TAC: Roofing

**This document created by the Florida Department of Business and Professional Regulation -
850-487-1824**

Total Mods for **Roofing** in **Approved as Submitted** : 9

Sub Code: Building

Figure 1a – Cleated Eave Edge Metal System – Cleat Disengagement

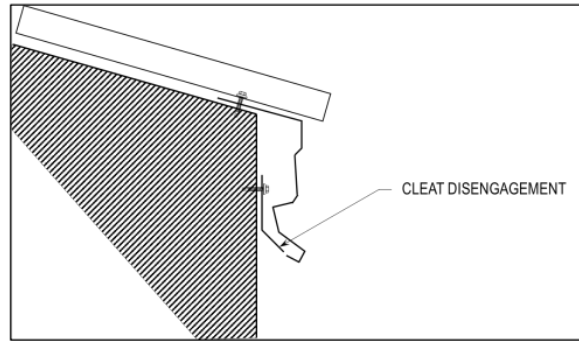
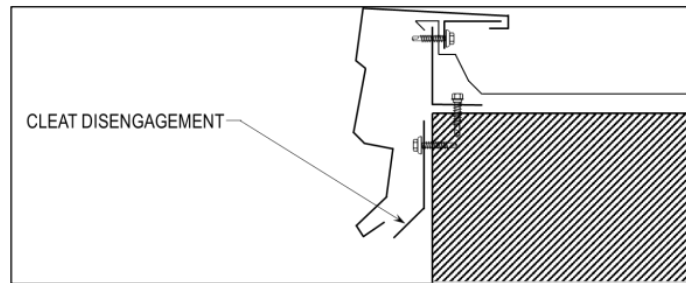
- Where a multi-piece edge trim assembly incorporating cleats deformed enough to disengage from the cleat. (Figures 1a and 2a)
- Where the metal edge trim assembly was fastened to a non-metal substrate such as wood or masonry, leaving to question the appropriateness of the fastener used since it would often not be provided by the edge system manufacturer for non-metal substrates. (Figures 1b and 2b)

Figure 1a – Cleated Eave Edge Metal System – Cleat Disengagement

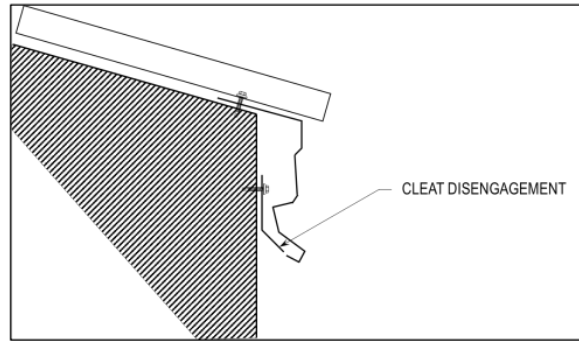
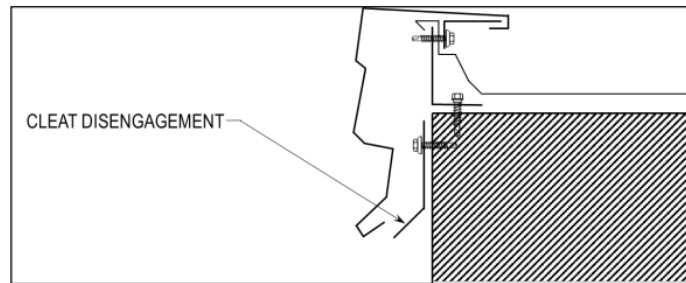
- Where a multi-piece edge trim assembly incorporating cleats deformed enough to disengage from the cleat. (Figures 1a and 2a)
- Where the metal edge trim assembly was fastened to a non-metal substrate such as wood or masonry, leaving to question the appropriateness of the fastener used since it would often not be provided by the edge system manufacturer for non-metal substrates. (Figures 1b and 2b)
